CONSTRUCTION OF THE MADRAS HARBOUR.

CONSTRUCTION OF THE MADRAS HARBOUR.

A. T. MACKENZIE, M.INST.C.E.,

Local Consulting Engineer to the Madras Harbour Trust.

MADRAS HARBOUR.

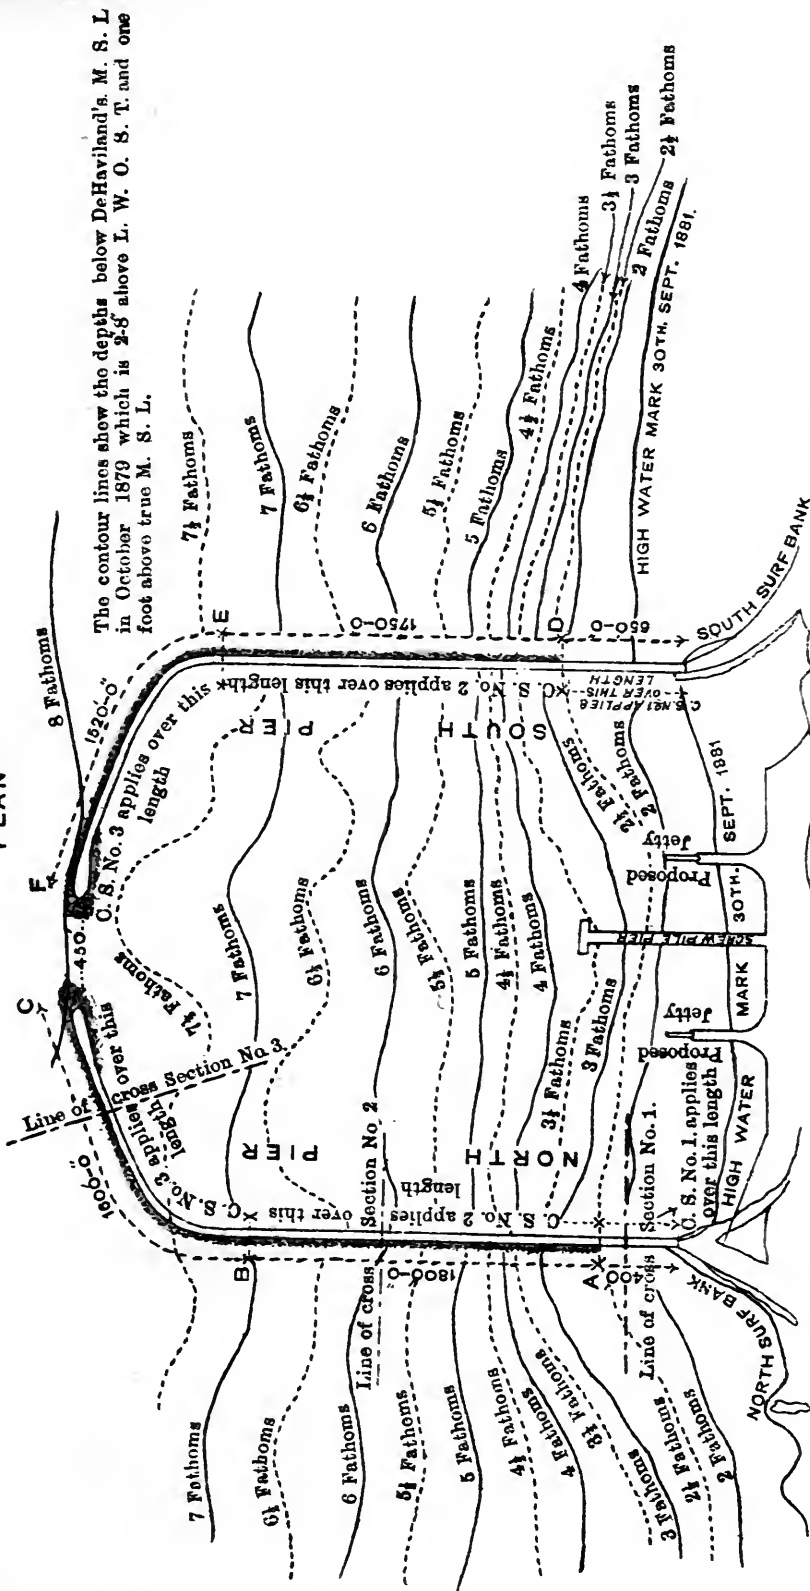
“ For the landward portion of the piers, the works we recommend to be undertaken (shown on Cross-section No. 1), consist of cramping each pair of blocks in the upper course, and the addition of a mass of concrete carried up to 12 feet above high-water spring tides, the level to which we consider it necessary to raise the piers throughout their entire length. This mass of

“For the next length of the piers, extending to the elbows, in addition to the cramping and the top mass of concrete, a wave-breaker, shown on Cross-section No. 2, of random concrete blocks, should be added on the seaward face, which will render it necessary to widen the rubble mounds. The concrete blocks for the wave-breakers should nowhere be less in weight than twenty tons.

CROSS SECTION NO. 4.

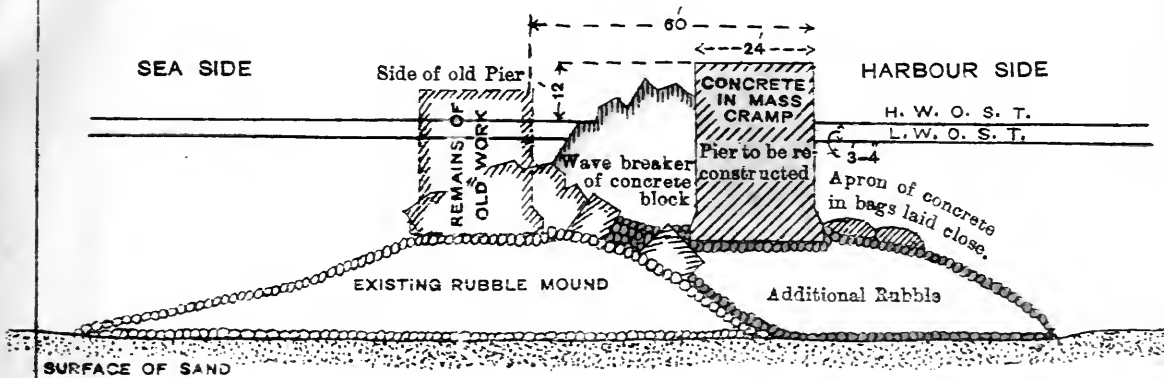
“The plan, therefore, we recommend for the reconstruction of the outer lengths from B on the north pier and E on the south pier, to the seaward ends, is in the first instance to endeavour to continue the walls on the old foundations, as shown on Cross-section No. 3. Before the elbows of the piers are finished it will be seen whether this plan can be successfully carried out; if so, the system should, we think, be followed. If not, the piers should be brought in to the extent of about 60 feet, following the design shown on Cross-section No. 4.

CROSS SECTION NO. 5.

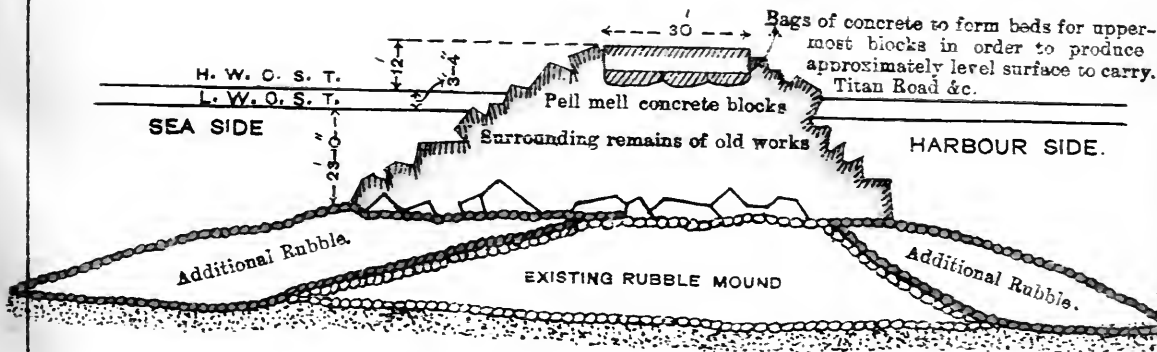
“ In considering the matters now referred to us, we have had interviews with Mr. Parkes, who has explained to us his views. He sees some difficulty, as we did, in carrying out the system shown on cross section No. 5, and seems farther to be of opinion that he should prefer to adopt cross sections 1, 2, and 4. With regard to this question, we think you may be guided by Mr. Parkes with the clear understanding, so far as we are concerned, that nothing is done to weaken any of the works recommended by us, whichever of the methods be adopted, and that the piers be not built to a lower level than we have already advised.

PROPOSALS FOR RESTORATION BY MADRAS SPECIAL COMMITTEE
 Plan showing North east entrance with protecting
 arm, suggested by Committee (with exceptions.)

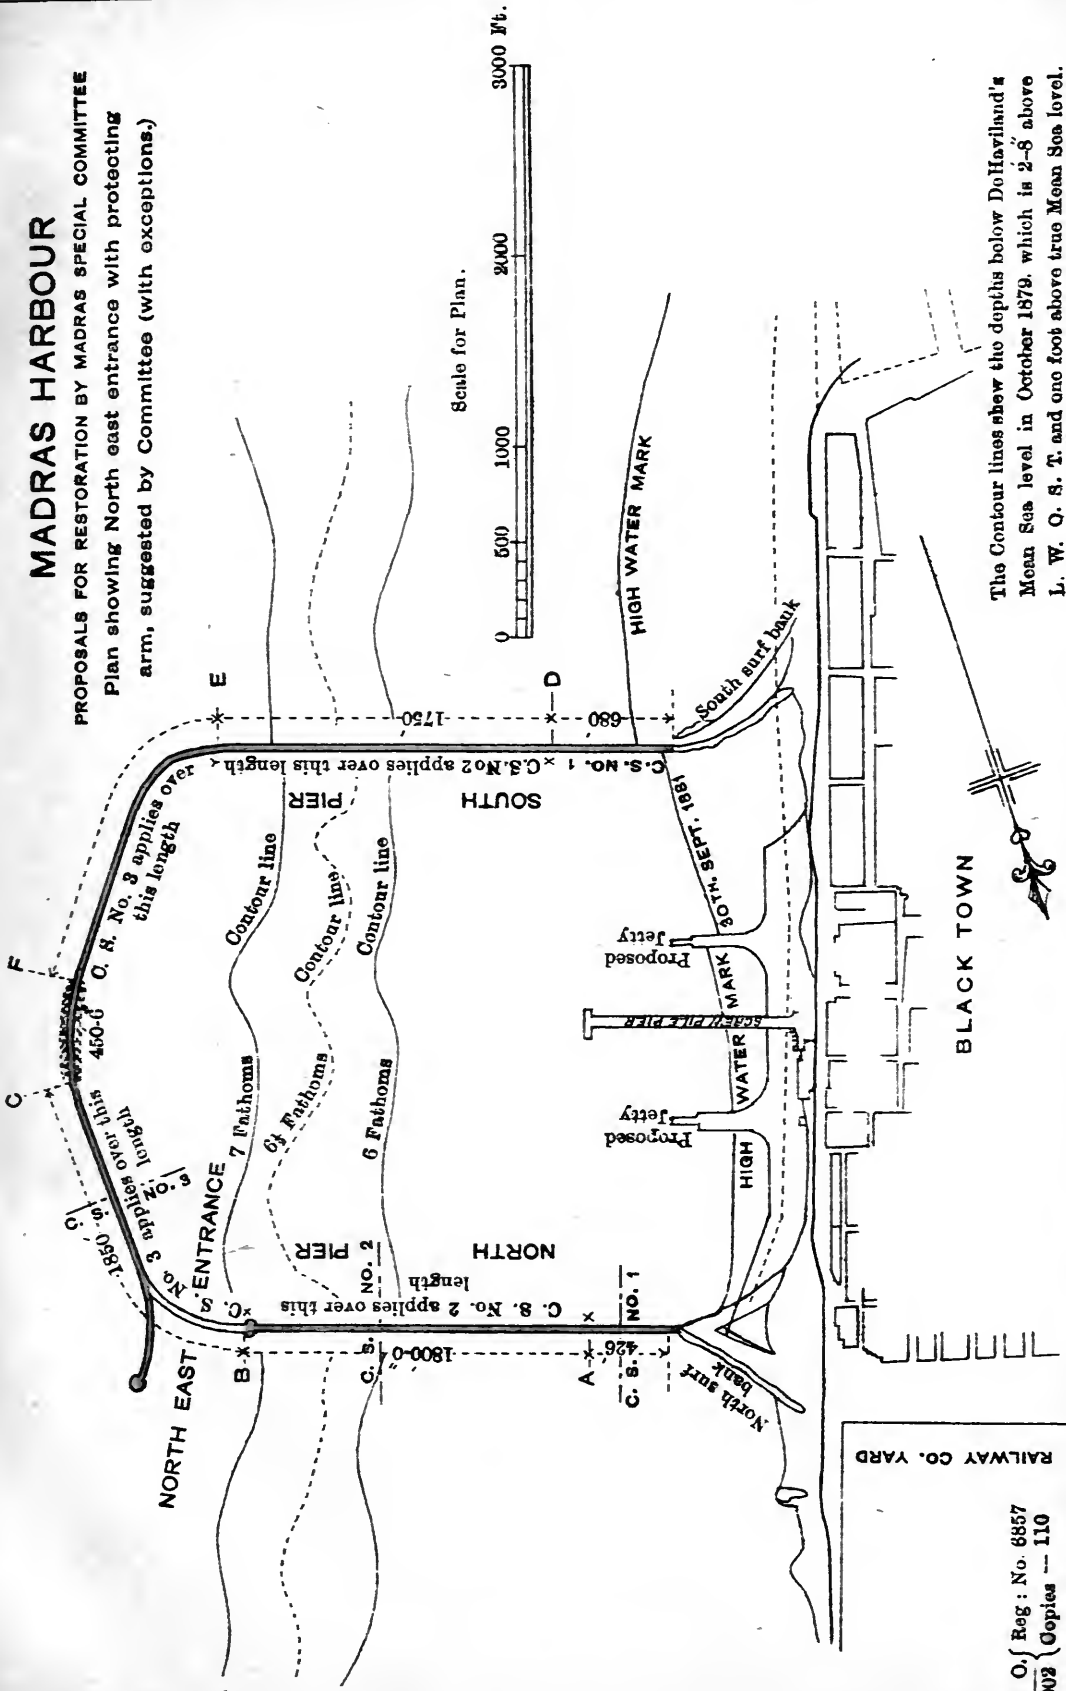
“The change suggested by the Madras Committee requiring the gravest consideration is their proposal to make a new entrance to the harbour at its north-eastern elbow and to stop up the existing entrance. Their object in making this proposal is to secure stiller water inside the harbour, a thing desirable in itself if attainable with due regard to other considerations, and they state that the work remodelled in this and in other respects as they recommend will cost much the same as the works advised by us in our report of the 23rd January 1883.

“It is, perhaps, more a nautical than an engineering question, but we fear that access and egress through this new entrance would, in cyclones, be very difficult, the difficulty increasing just in proportion as the entrance was made to face the north, and diminishing as it faced easterly. Even with the north-easterly kant shown on the Madras Committee's plan, vessels could not make or leave the harbour without being exposed to waves striking them on their beam, and tending to heel them over, or to carry them into shoal water on shore, or to cause them to strike against the end of the northern pier.

“After giving the fullest consideration to this question, we cannot recommend the construction of the proposed new entrance.

Diagram No. 3 to accompany note by Mr. MOLESWORTH dated July 17th 1883.

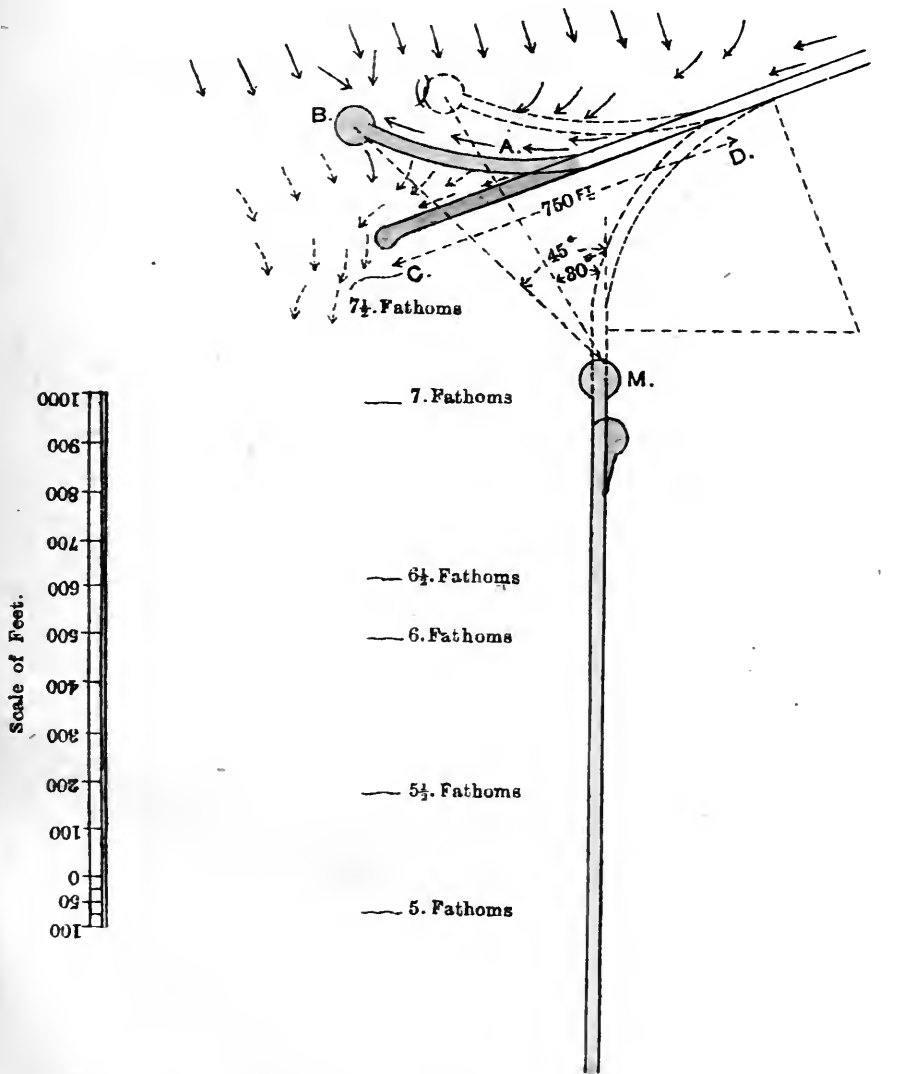
“Assuming, however, the feasibility of such an entrance, I am of opinion that the form of breakwater proposed for covering this entrance requires some modification. In its proposed form it is open to serious objections, involving, as it does, a re-entering curve which would never stand the blow of a cyclonic wave.

NOTE - The dotted lines shew the breakwater as proposed by the Madras Committee. The portions coloured black shew the increased length suggested by Col. Trevor. The portions coloured red shew the modification proposed by Mr. Molesworth.

And he proposed certain modifications.

PROPOSAL OF SPECIAL COMMITTEE IN MADRAS 1883.

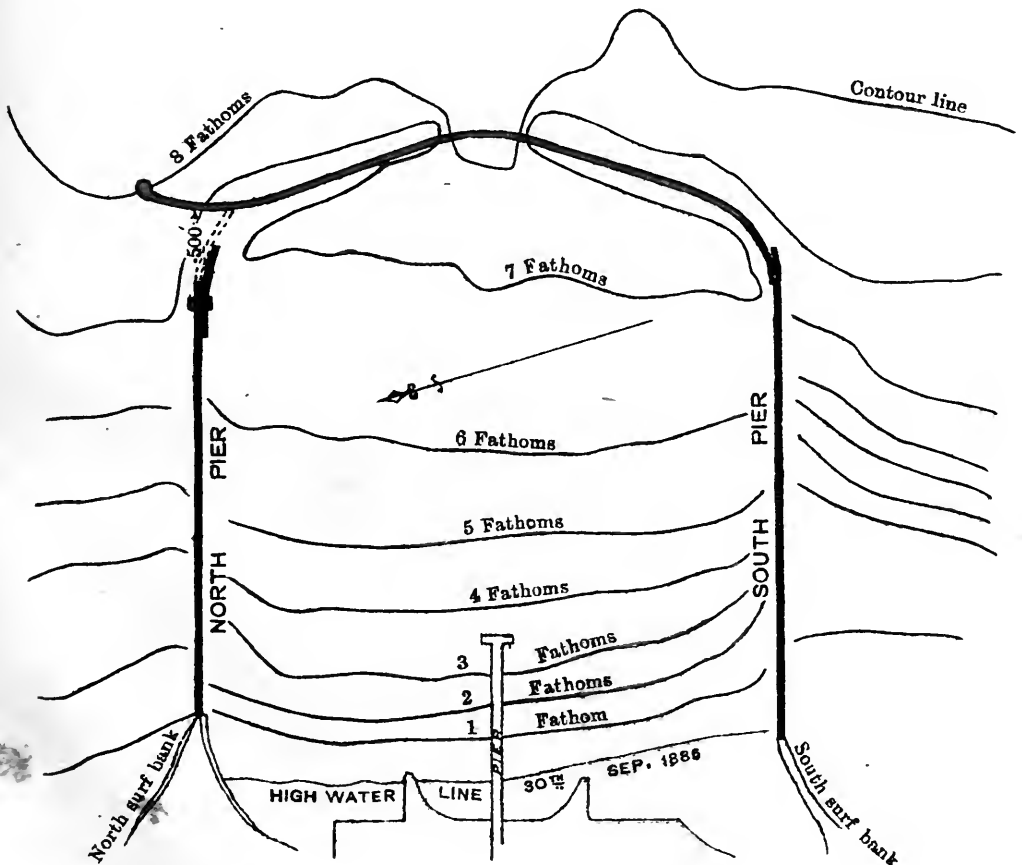
4th.—The re-entering curve proposed by the Madras Committee in the overlapping arm to the north-east elbow is open to serious objections, but I notice that Mr. Thorowgood, in his letter, dated January 31st, 1887, has submitted a sketch in which this is modified to meet the objection to a re-entering curve raised in my note of July 17th, 1883.
